Massachusetts Military Reservation

Final Explanation of Significant Differences for Chemical Spill-4, Chemical Spill-20, Chemical Spill-21, Fuel Spill-13, Fuel Spill-28, and Fuel Spill-29 Groundwater Plumes

September 2008

Prepared by:
Jacobs Engineering Group Inc.

Figure 3-5

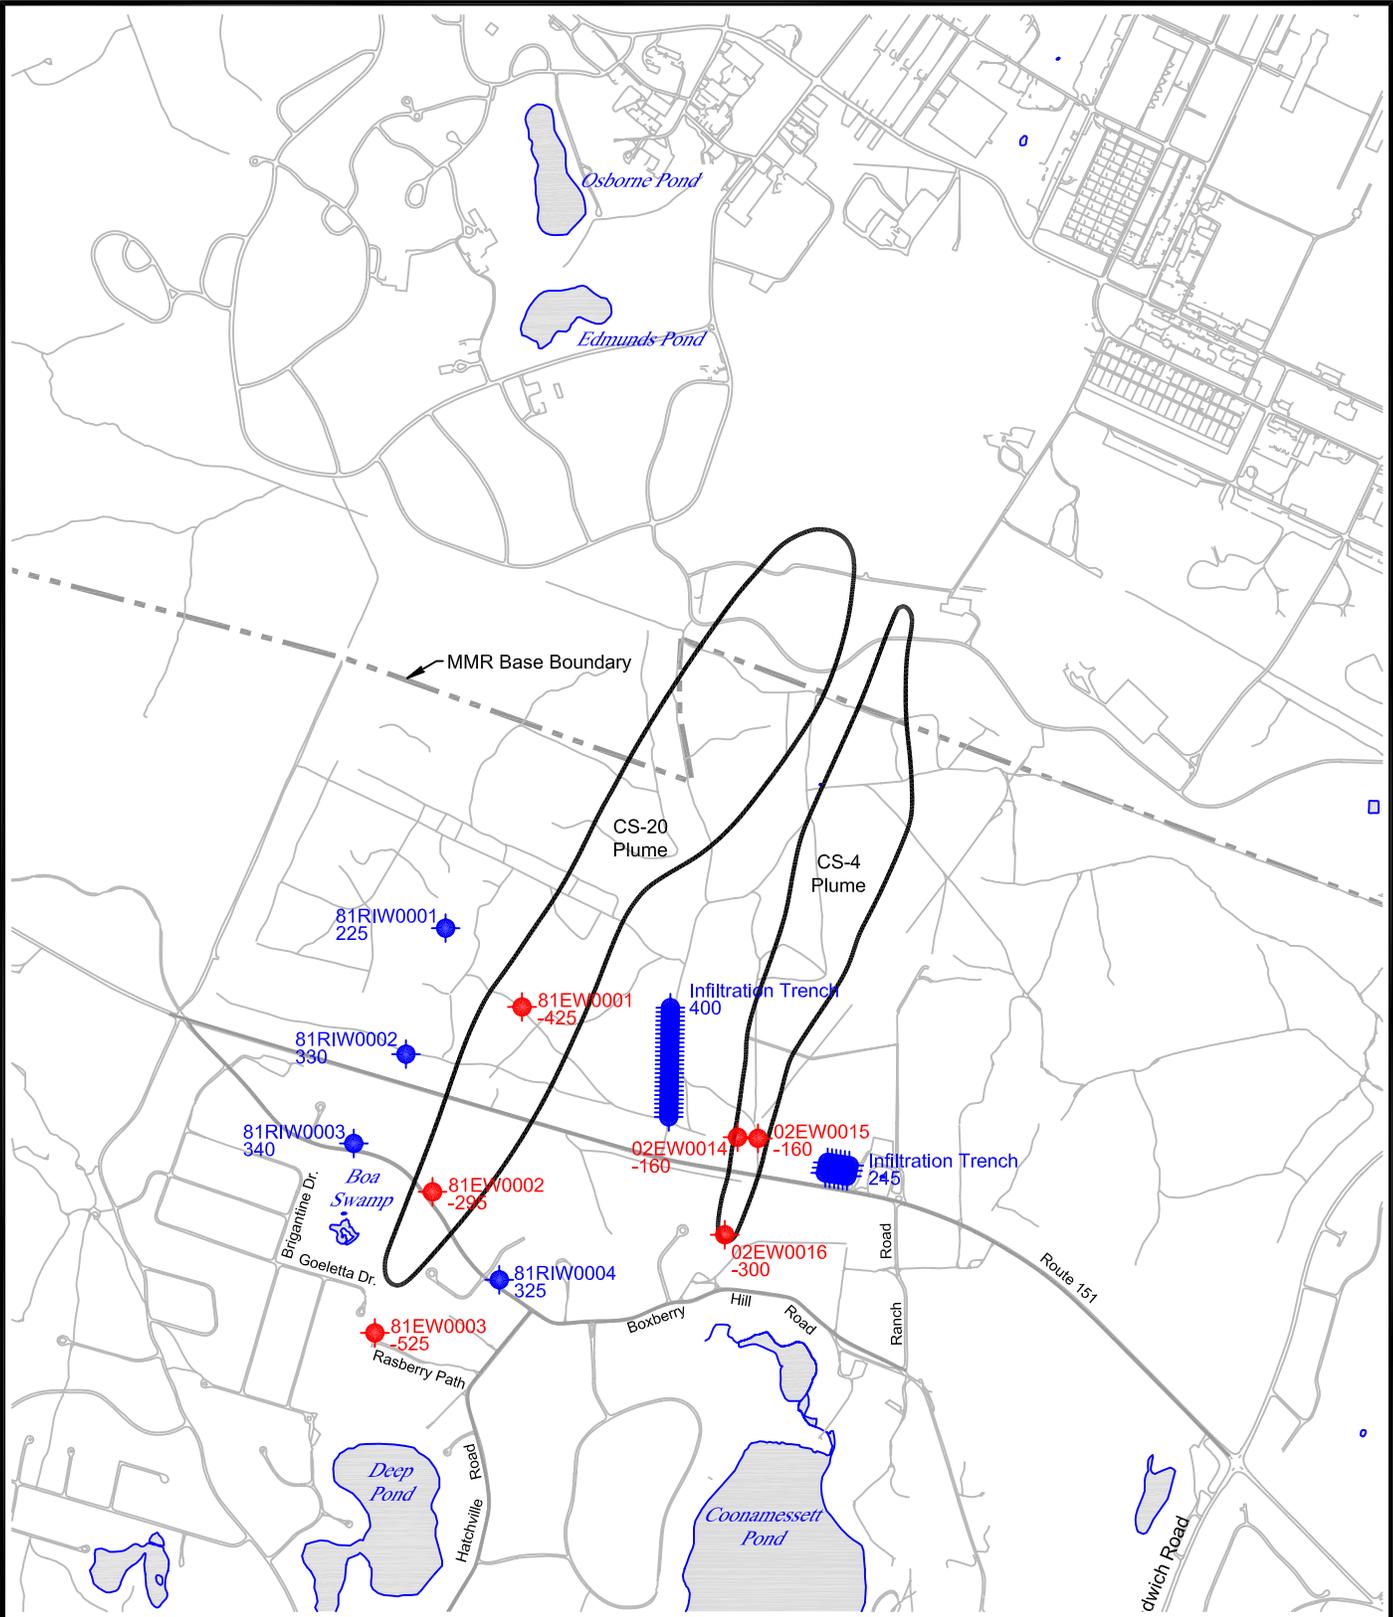
The wellfield design for the CS-20 plume presented in the *Final Chemical Spill-4, Chemical Spill-20, Chemical Spill-21, and Fuel Spill-29 Wellfield Design Report* (AFCEE 2004a) consisted of three axially located wells (Figure 3-5). The most downgradient well was located downgradient of the 2002 CS-20 plume based on model-predicted location of the plume in 2005.5 (system start date assumed for the wellfield design modeling). After the wellfield design report AFCEE contacted property owners in the vicinity of the leading edge extraction well (along Raspberry Path and Goeletta Drive) but was unable to acquire access from private property owners in the area necessary for the leading edge extraction well. AFCEE approached the Town of Falmouth to gain access for placement of the leading edge well in the town-owned road Goeletta Drive but the Town was reluctant to grant access. At the same time AFCEE continued to gather plume contaminant information (2005 and 2006) to refine the understanding of the leading edge contaminant distribution; specifically, drilling and sampling using sonic and direct push technology was conducted along Boxberry Hill Road, Brigantine Drive, and Goeletta Drive. The results indicate that the CS-20 plume does not extend south to Goeletta Drive. The drilling results were used with monitoring well sampling data to construct the CS-20 2006 plume shell. The 2006 CS-20 plume only extends approximately 800 feet south of Boxberry Hill Road (Figure 3-3) compared to the wellfield design modeling, which predicted that in 2006 the CS-20 plume would extend approximately 2,300 feet south of Boxberry Hill Road to Raspberry Path. Based on the 2006 CS-20 plume shell, it was estimated that the total 2006 CS-20 plume mass (dissolved and adsorbed) is 162 lb with approximately 8.7 lb predicted to be downgradient of the capture zone at the time of system startup (Figure 3-3) (AFCEE 2008a). Model predictions of the operation of the CS-20 remedial system indicate a small portion of the plume with PCE concentrations above 50 µg/L is outside the capture zone (Figure 3-3). The uncaptured portion of the plume quickly decreases in concentration through natural attenuation. The maximum distance the uncaptured portion of the CS-20 plume, as defined by above-MCL concentrations, is predicted to migrate downgradient is approximately 1,300 feet. Most of the plume is predicted to reach cleanup levels by approximately 2016 with some contamination retained in low-
